## ORIGINATION FORM

Proposed Revisions to a Standard Plans Index  
(Please provide all information — Incomplete forms will be returned)

Index Number: 711-003  
Sheet Number (s): 5 and 6  
Index Title: Interchange Markings

INDEX SHEET  
711-003 5 of 8

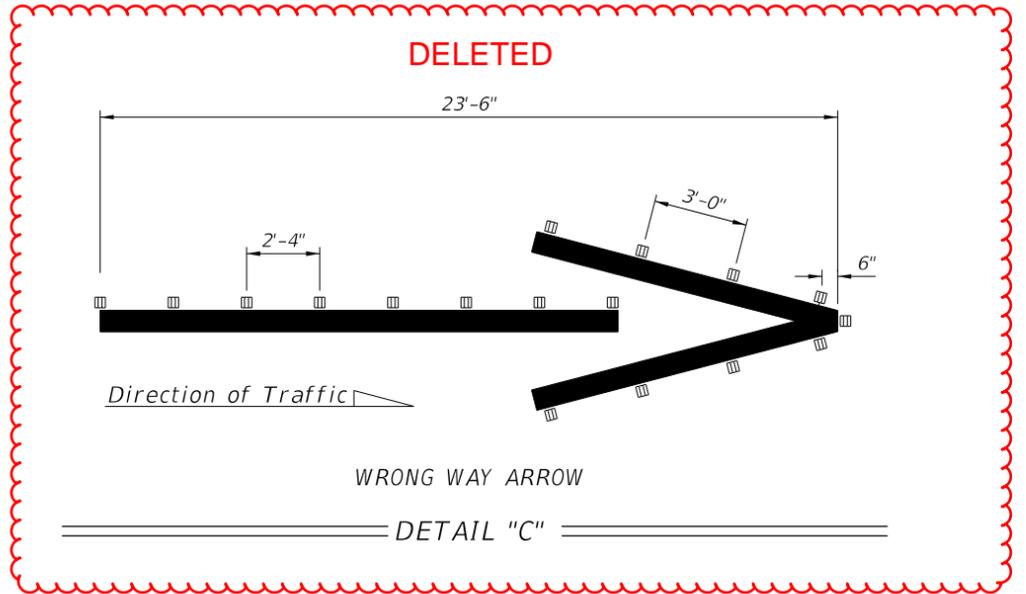
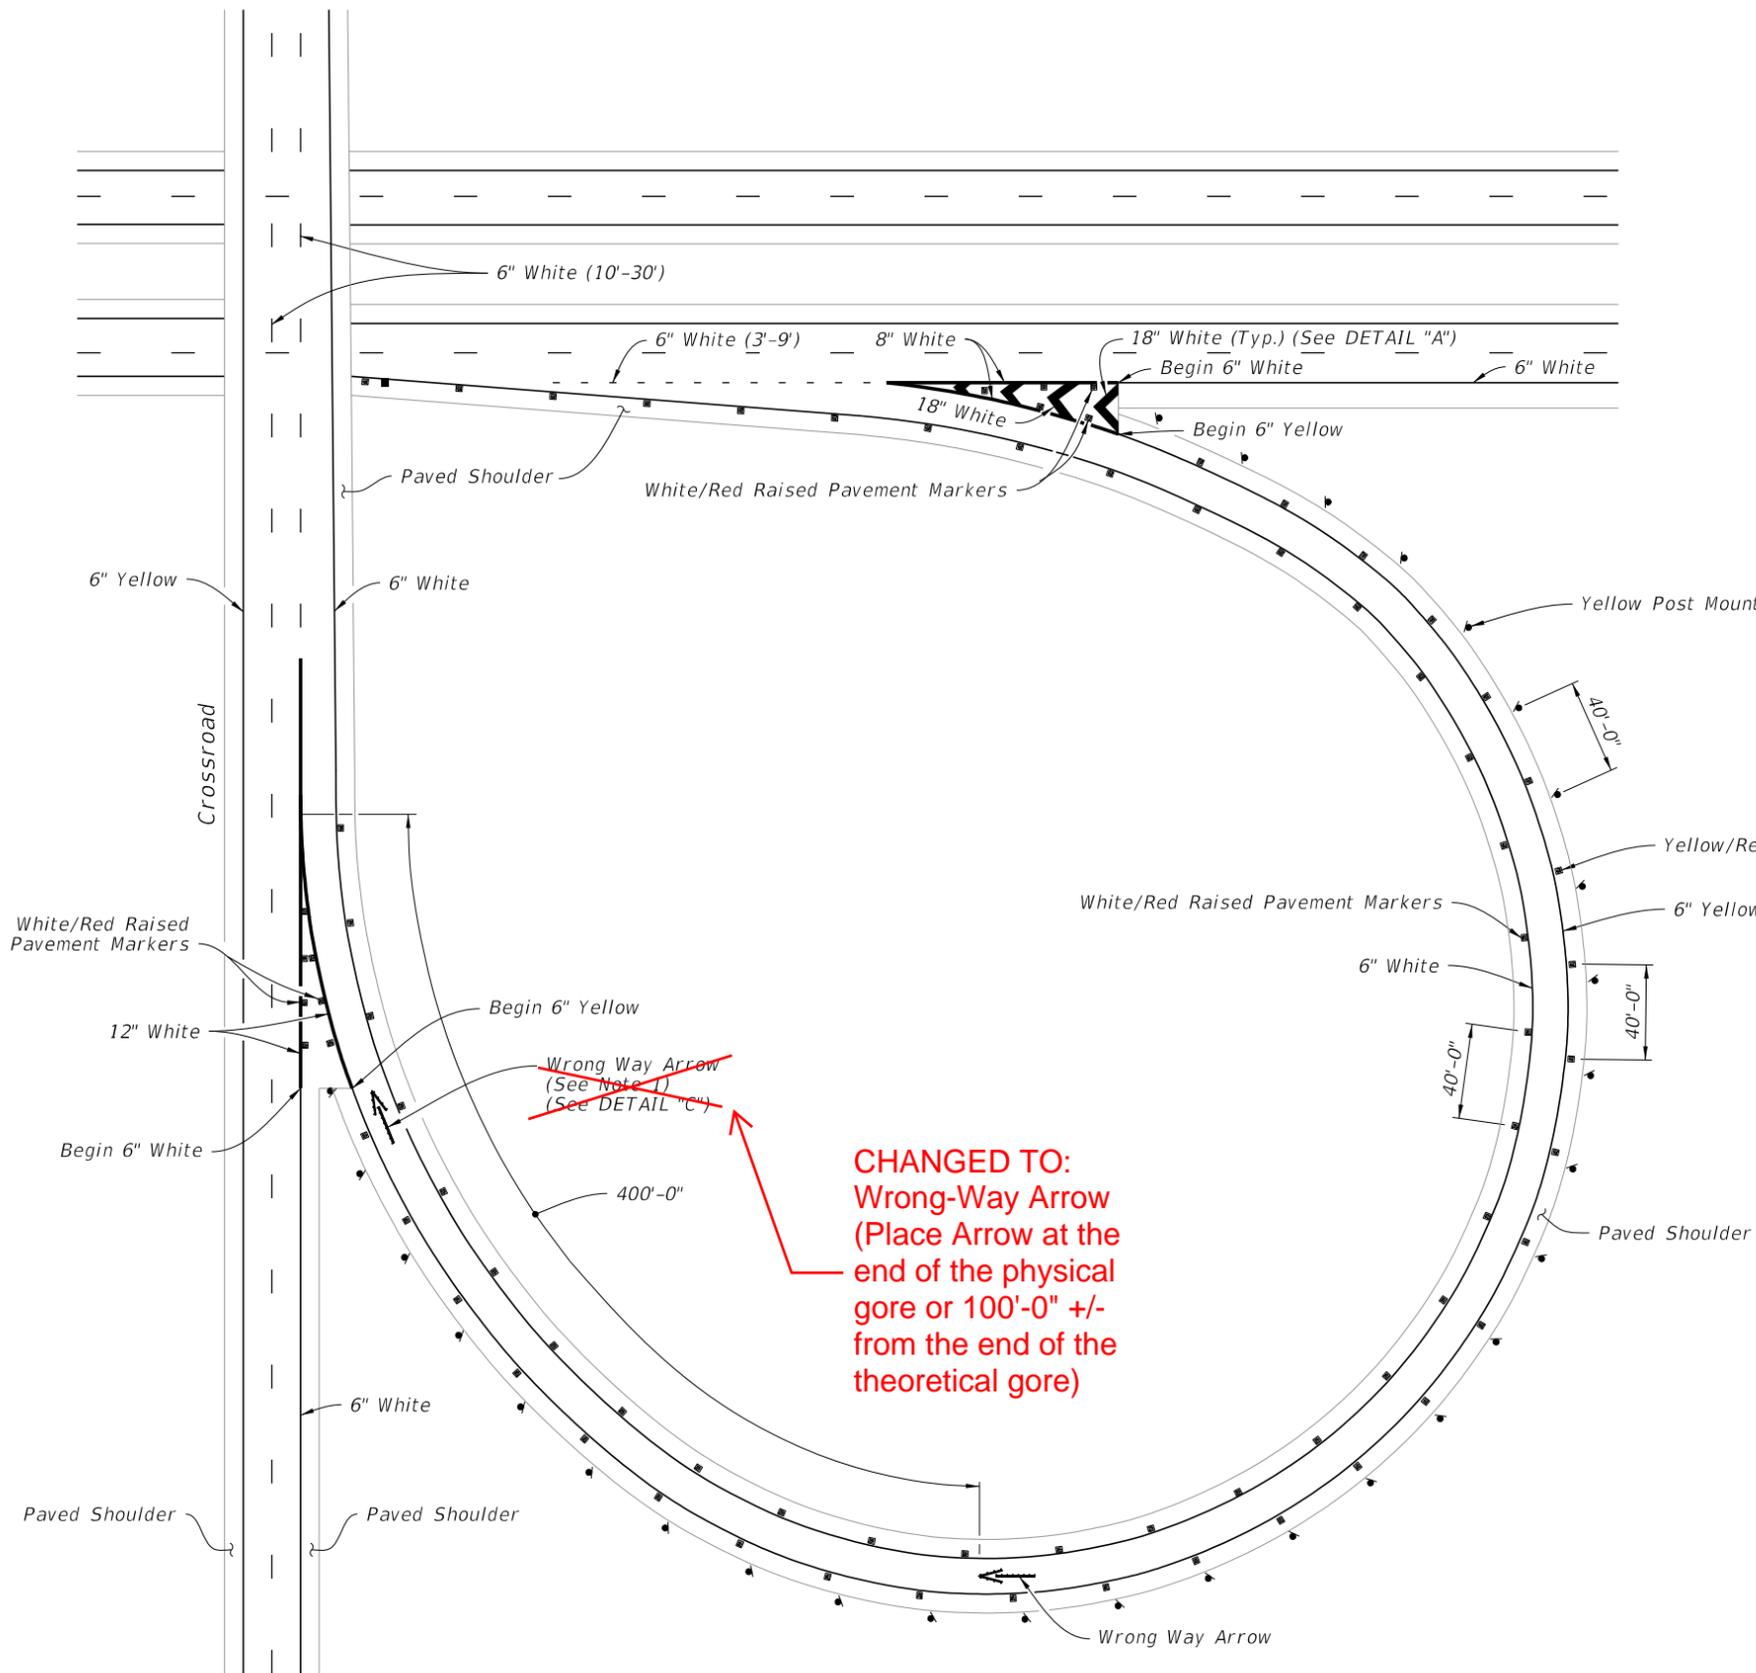
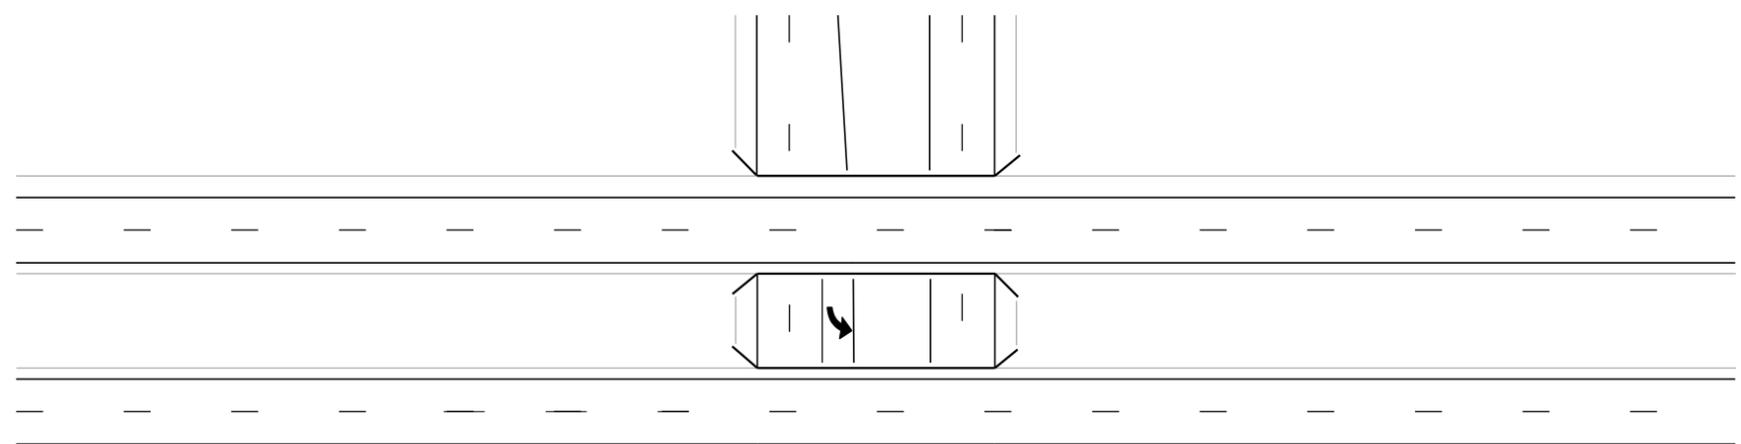
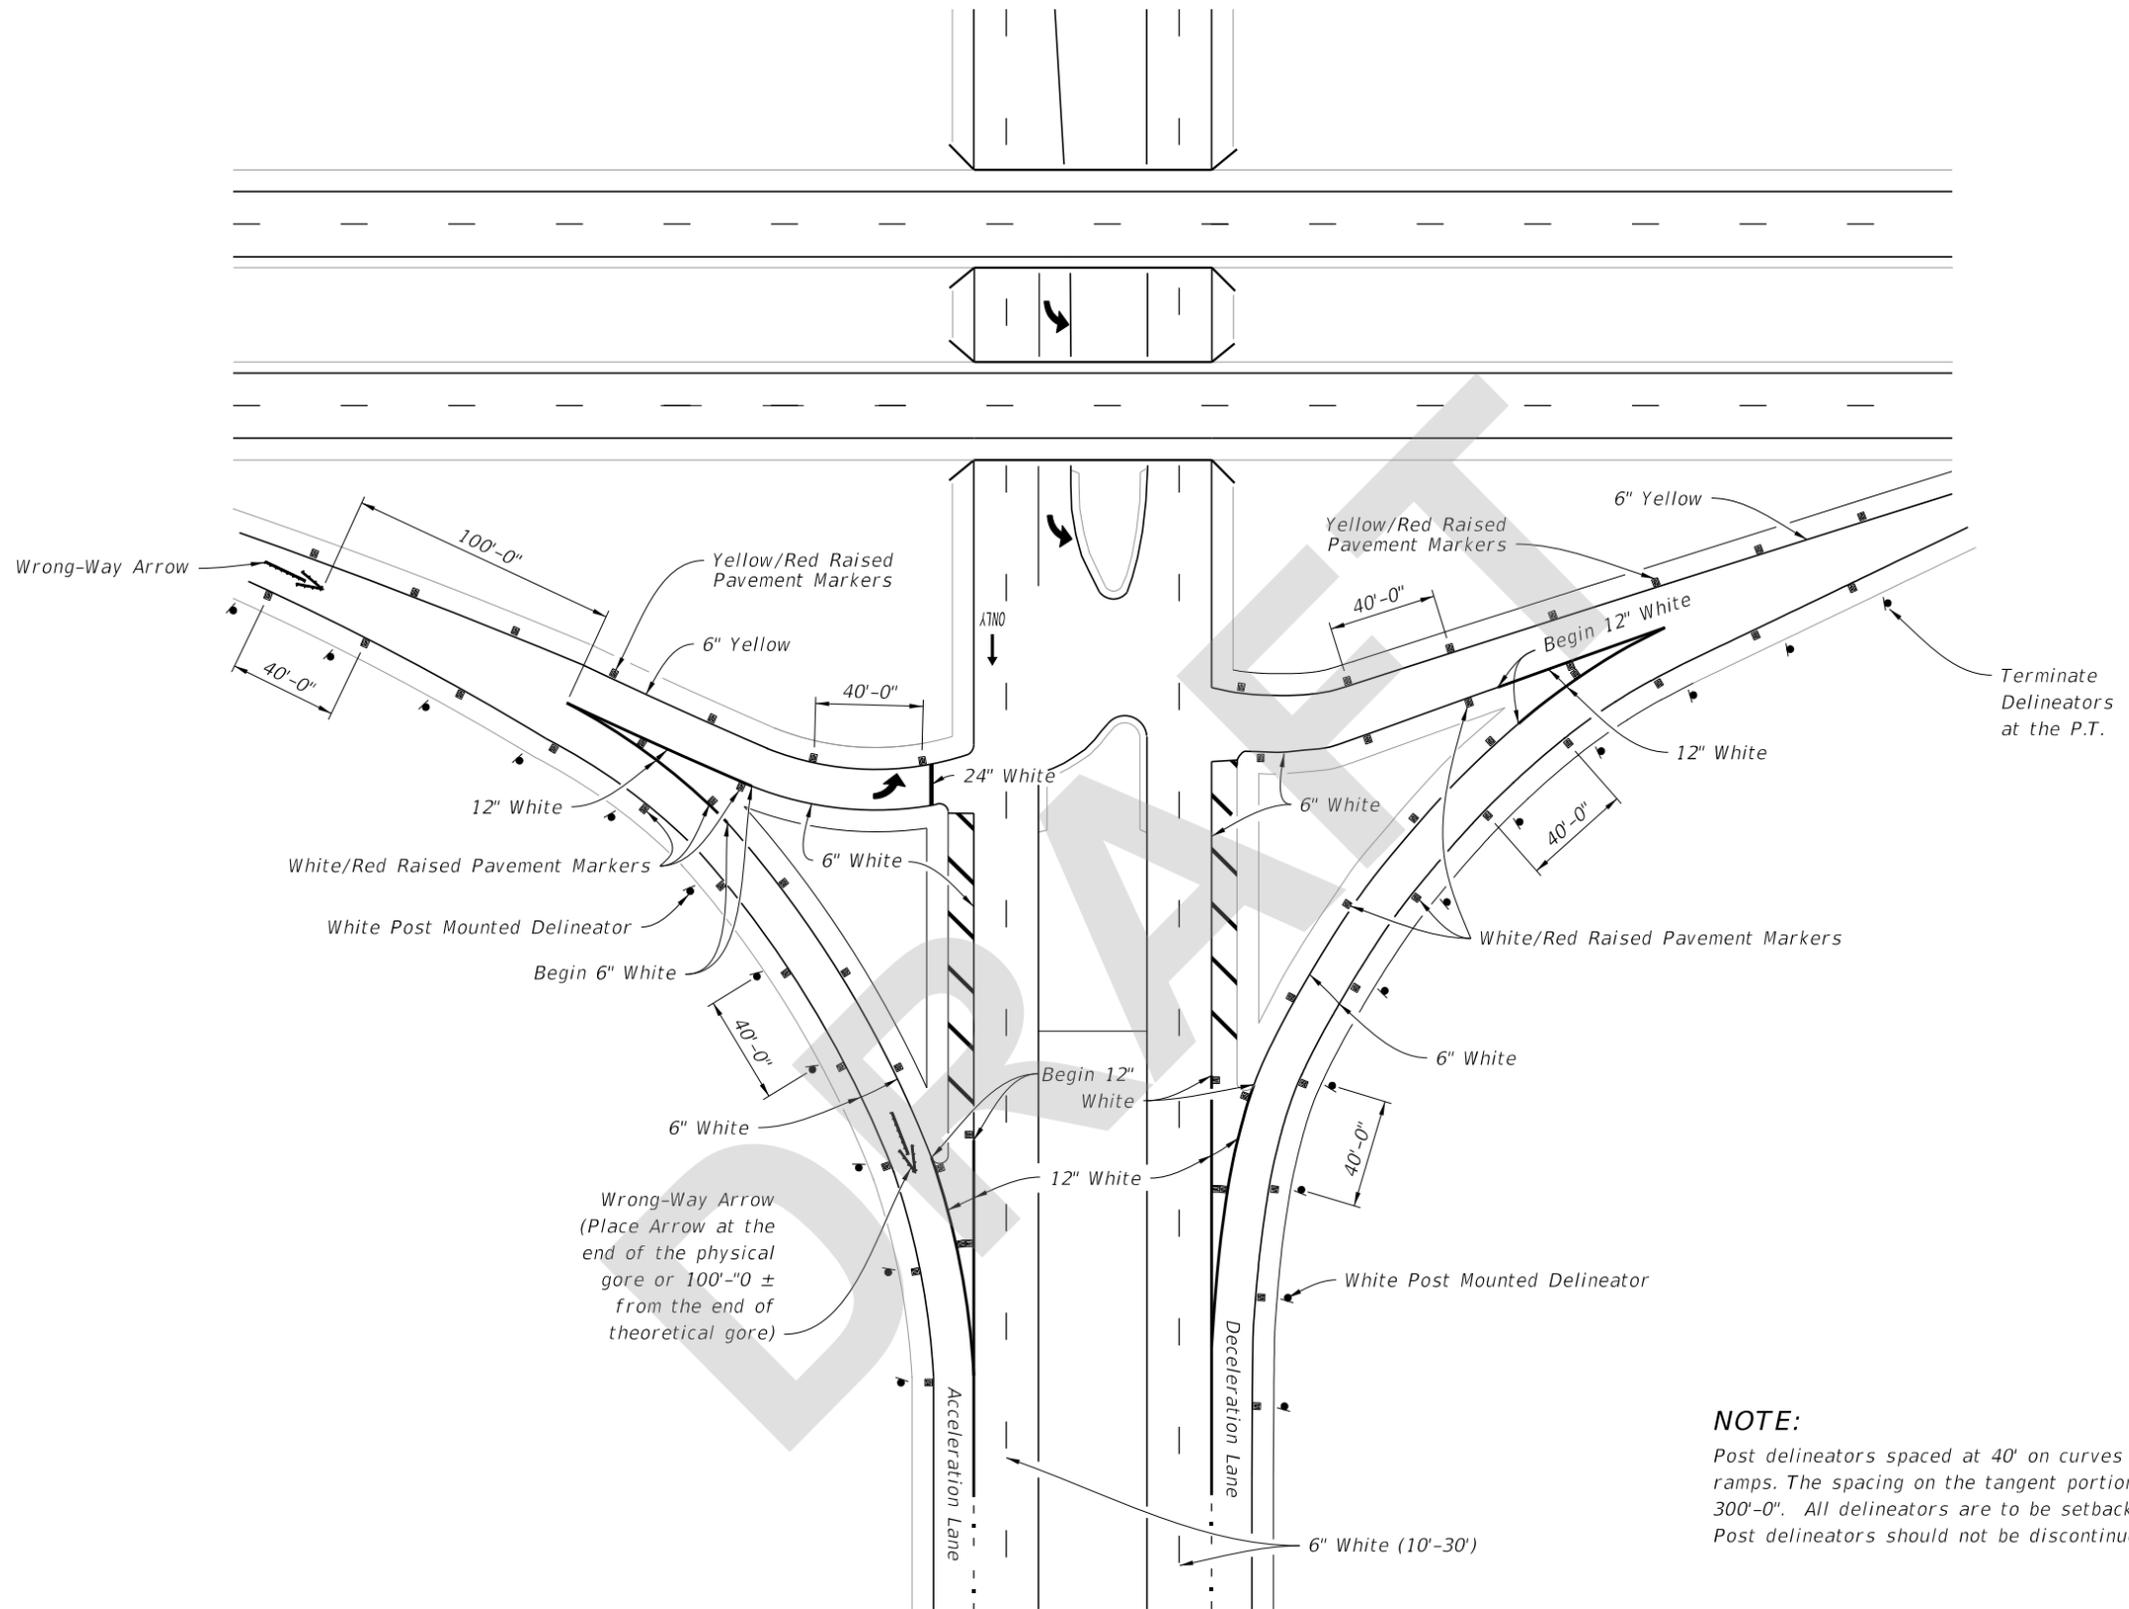
Sheet 5: Moved Detail "C" from sheet 5 to Sheet 3 of Index 706-001; Moved Note 1 to the Wrong-Way Arrow callout at the Gore; Deleted Note 2; Deleted the "See Note 3" reference from the Yellow Post Mounted Delineator callout.

~~Wrong Way Arrow  
(See Note 1)  
(See DETAIL "C")~~

**CHANGED TO:  
Wrong-Way Arrow  
(Place Arrow at the  
end of the physical  
gore or 100'-0" +/-  
from the end of the  
theoretical gore)**

- ~~1. Place the Wrong Way Arrow at the gore.~~
- 2. Post delineators spaced at 40' on curves of the entrance and exit of ramps. The spacing on the tangent portion of the ramp section is 300'-0". All delineators are to be setback 4' from shoulder break. Post delineators should not be discontinued in sections with guardrail.

Deleted from title

~~TYPICAL CURVED EXIT RAMP AND WRONG WAY ARROW~~

**NOTE:**  
 Post delineators spaced at 40' on curves of the entrance and exit of ramps. The spacing on the tangent portion of the ramp section is 300'-0". All delineators are to be setback 4' from shoulder break. Post delineators should not be discontinued in sections with guardrail.
